CWM CHEMICAL SERVICES, LLC

Re: Additional Information Department of the Army Application No. 2000-01534, New York State Department of Environmental Conservation No. 9-2934-00022/00230

**CWM RESPONSE TO REQUEST FOR ADDITIONAL
INFORMATION
JOINT APPLICATION FOR PERMIT
FOR RESIDUALS MANAGEMENT UNIT NO. 2
USACE REQUEST (dated August 26, 2013)**

Arcadis Drawing “Stockpile Locations: Existing and Potential”

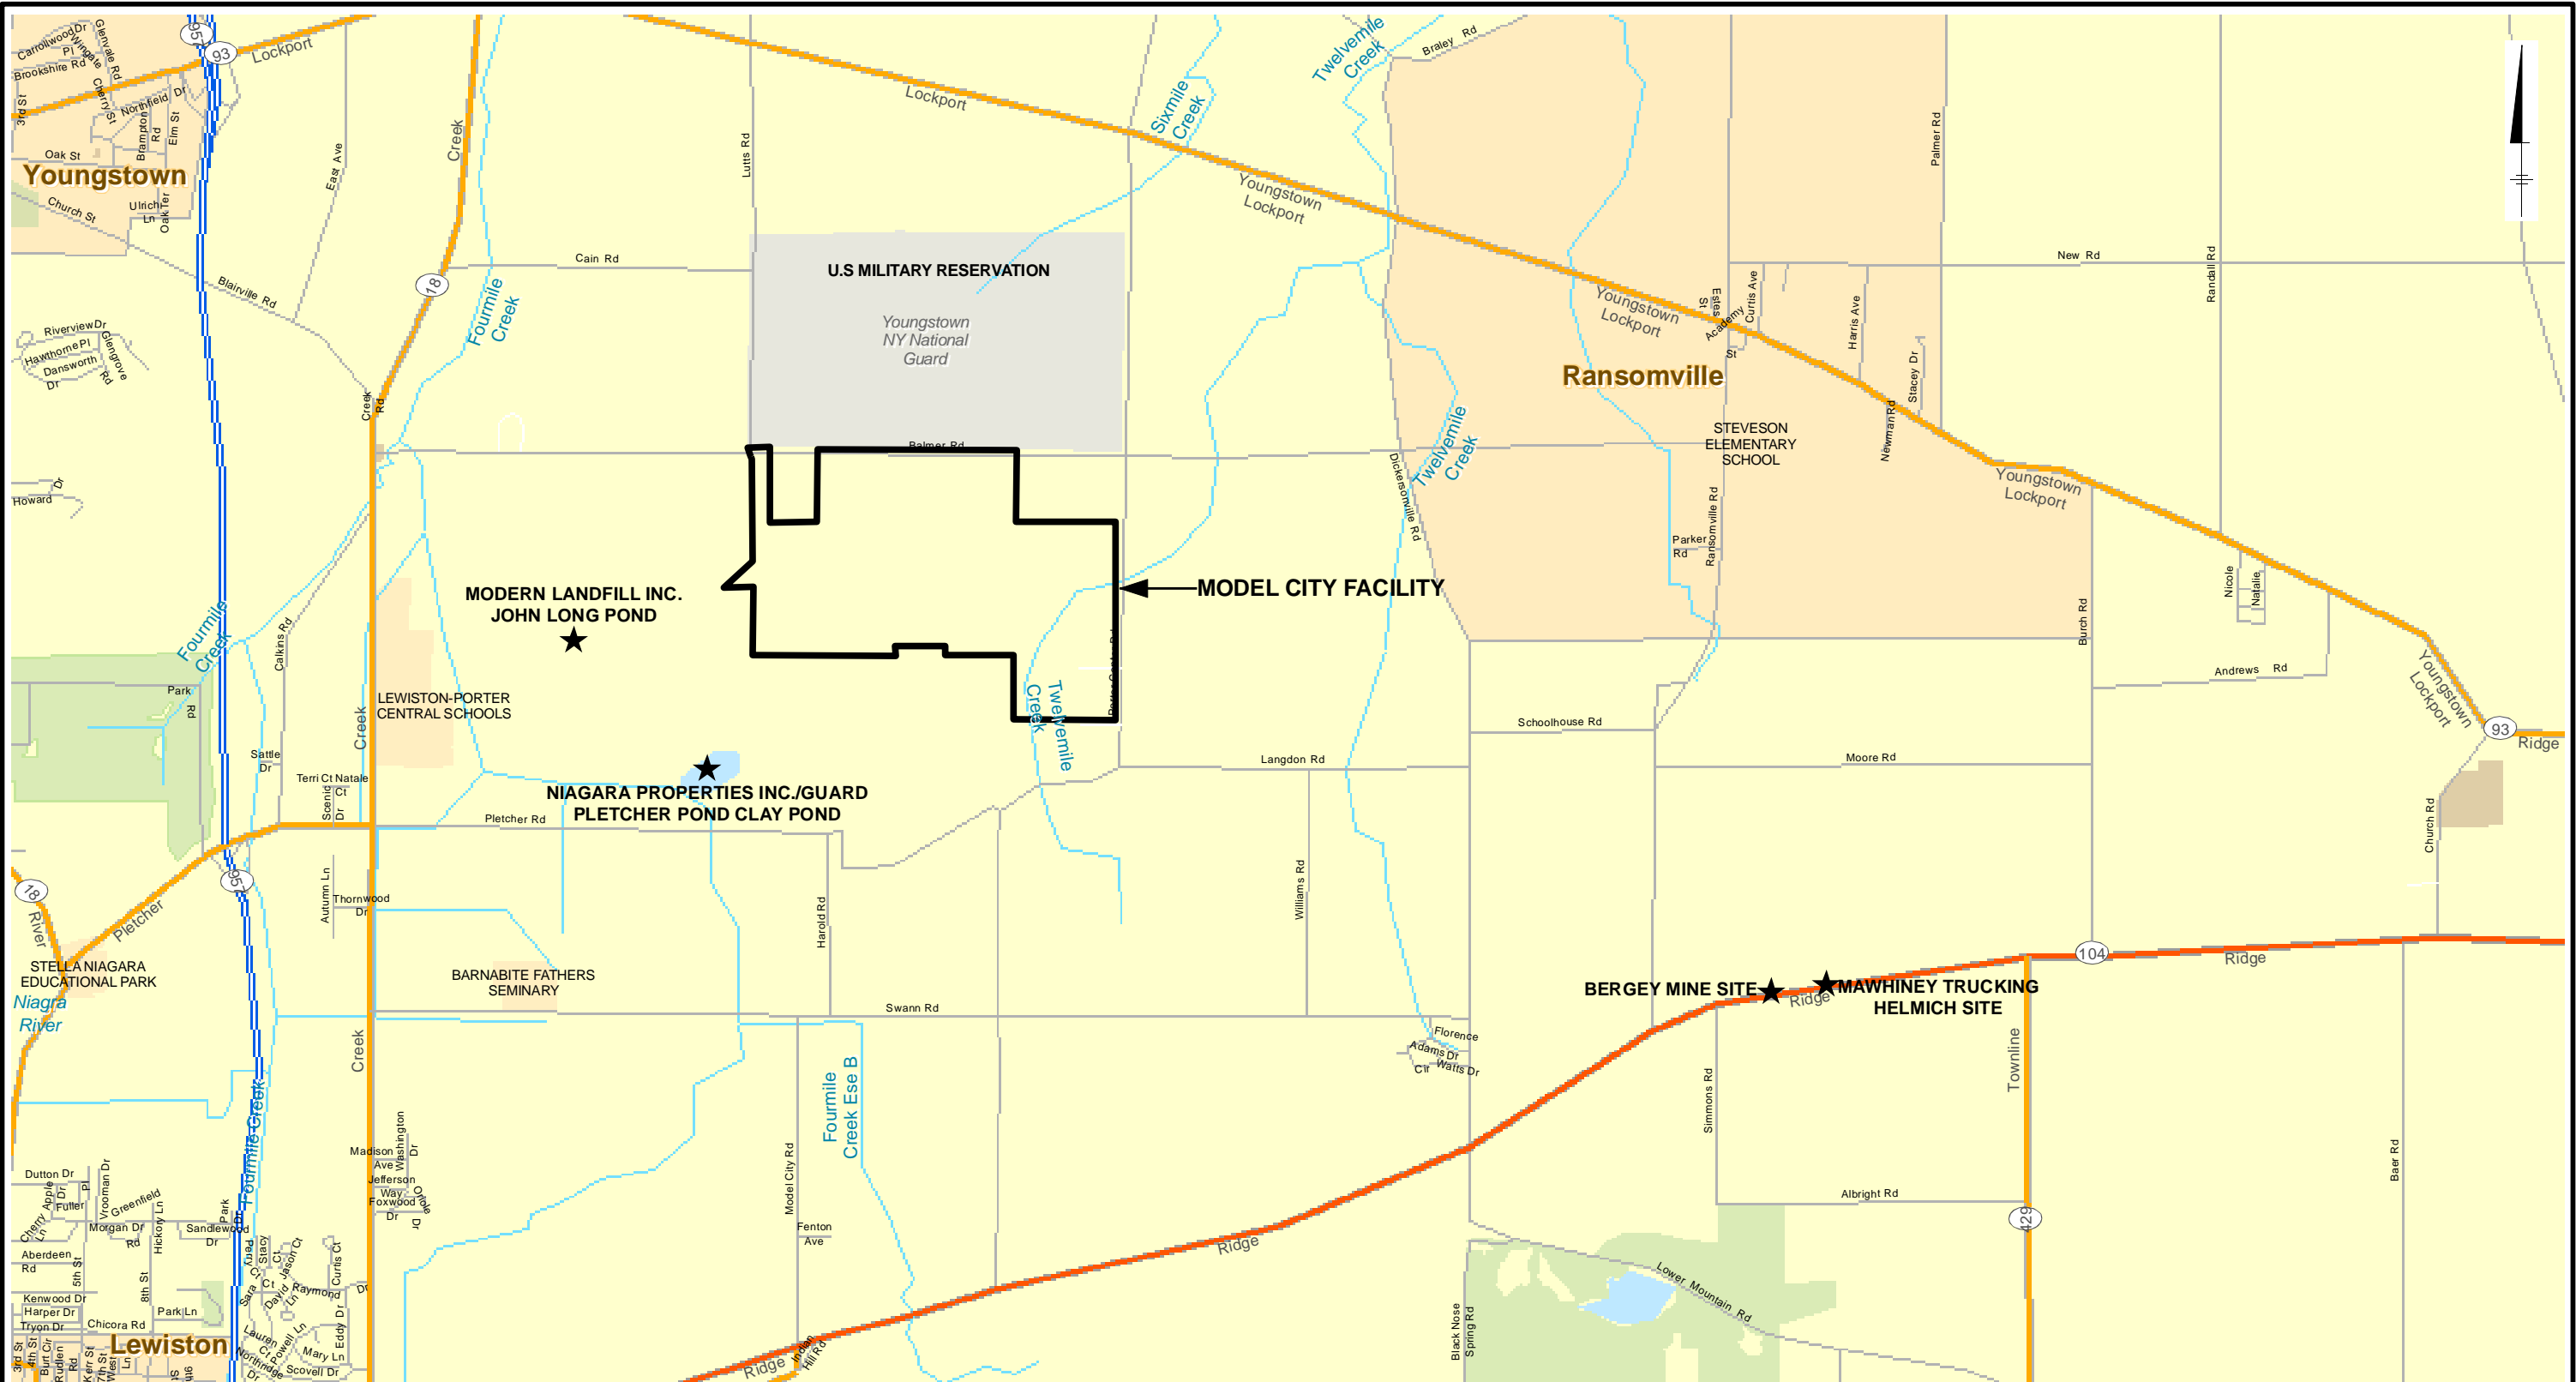
Please identify the areas (if any) that will be used as soil borrow/stockpile areas.

Appendix H of the Draft Environmental Impact Statement (DEIS) for the RMU-2 Project provides a soil management plan. Figure 1 from Appendix H of the DEIS is attached (Attachment 1) which shows current and potential soil stockpile locations that may be utilized during the development of RMU-2. A portion of the required soil materials for construction will be obtained from on-site excavation for RMU-2 and Fac Pond 5. Soils not available on site will be obtained from off-site sources on a contract basis. Section 2.6.6.5 and Appendix C of the DEIS provides details of potential off-site permitted borrow sources that may be utilized for the RMU-2 project. Also attached is a map showing the location of potential off-site soil borrow sources.
